UNITED STATES PATENT AND TRADEMARK OFFICE

APPLICATION NO.	FILING DATE	FIRST NAMED INVENTOR	ATTORNEY DOCKET NO.	CONFIRMATION NO.
10/684,792	10/14/2003	James Vlaanderen	00868P0026US	2996
32116	7590	12/14/2005	EXAMINER	
WOOD, PHILLIPS, KATZ, CLARK & MORTIMER 500 W. MADISON STREET SUITE 3800 CHICAGO, IL 60661			ADAMS, GREGORY W	
			ART UNIT	PAPER NUMBER
			3652

Office Action Summary	Application No.	Applicant(s)	
	10/684,792	VLAANDEREN ET AL.	
	Examiner	Art Unit	
	Gregory W. Adams	3652

FIG. 1

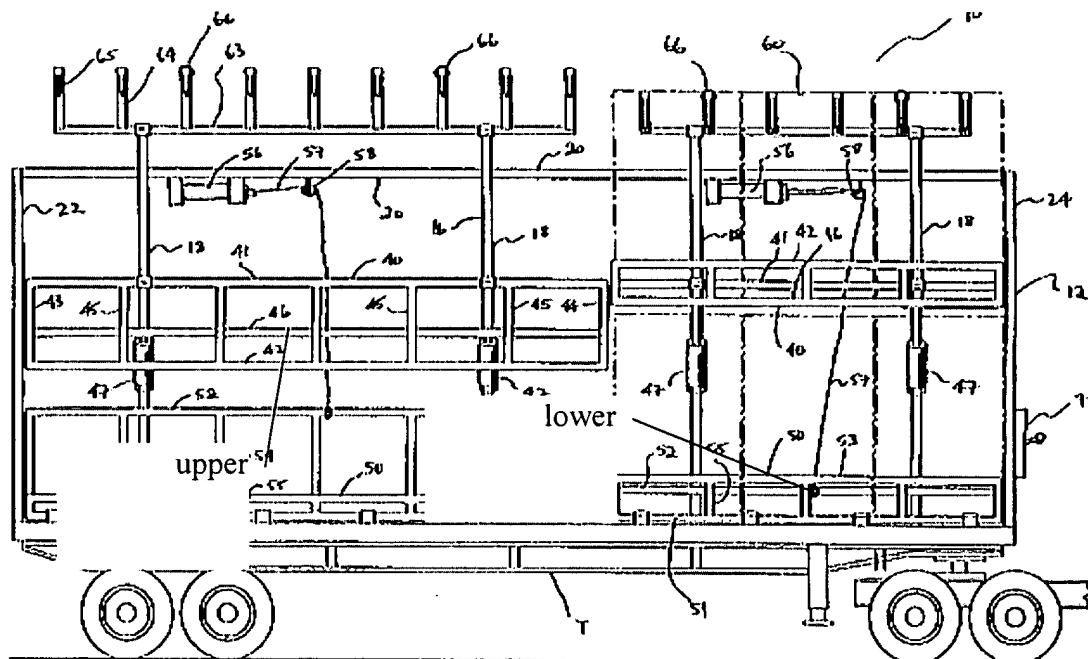
7. With respect to claim 8-9, Babb discloses that lower object supports are shorter than upper object supports (FIG. 1 below), and discloses sharing a first pivot 14. It is

noted that Babb discloses eight (8) object supports such that two (2) lower object supports and linkages thereof share pivot 14, and long links 45 of upper most object support 40 are longer than long links 55 of lowermost object support 50. Babb teaches an apparatus that transports cylindrical objects in rows and tiers, with the ability to pivot rotatably object supports from a loaded position to an unloading position. Para. [0002] – para. [00013]. Therefore, it would have been obvious to one having ordinary skill in the art at the time the invention was made to modify the apparatus of Foote to include shared linkages and object supports which are shorter and longer and longer uppermost long links, as per the teachings of Babb, to transport cylindrical objects in rows and tiers, with the ability to pivot rotatably object supports from a loaded position to an unloading position.

13. With respect to claim 14, Babb discloses that lower object supports are shorter than upper object supports (FIG. 1 above), and discloses sharing a first pivot 14. It is noted that Babb discloses eight (8) object supports such that two (2) lower object supports and linkages thereof share pivot 14, and long links 45 of upper most object support 40 are longer than long links 55 of lowermost object support 50. Babb teaches an apparatus that transports cylindrical objects in rows and tiers, with the ability to pivot rotatably object supports from a loaded position to an unloading position. Para. [0002] – para. [00013]. Therefore, it would have been obvious to one having ordinary skill in the art at the time the invention was made to modify the apparatus of Foote to include shared linkages and object supports which are shorter and longer and longer uppermost

With respect to claim 14, Applicant did not provide arguments, but likely intended to argue that Foote in view of Babb does not disclose object supports of different lengths. Babb discloses that lower object supports are shorter than upper object supports (FIG. 1 reproduced above), and discloses sharing a first pivot 14. It is noted that Babb discloses eight (8) object supports such that two (2) lower object supports

and linkages thereof share pivot 14, and long links 45 of upper most object support 40 are longer than long links 55 of lowermost object support 50. Because one is shorter, Babb discloses different lengths.

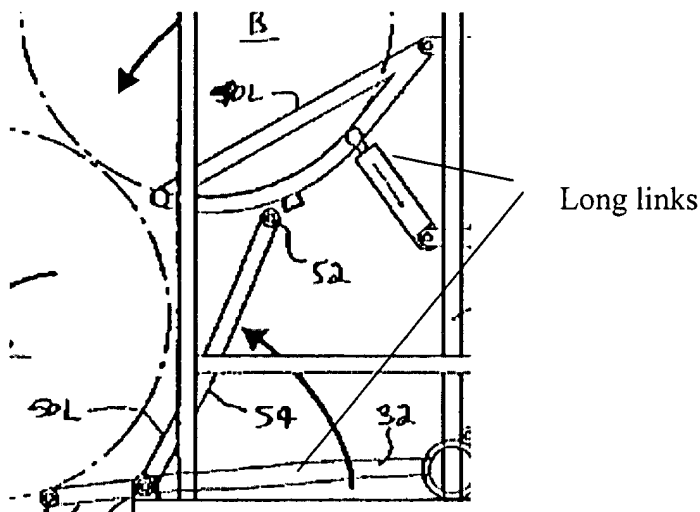
With respect to claim 13, Applicant argues that Foote does not disclose long links for on cradle being longer than long links for another cradle. Fig. 3 reproduced below shows long links and shorts links, with long links for cradle 50L longer than long links for cradle 40L.
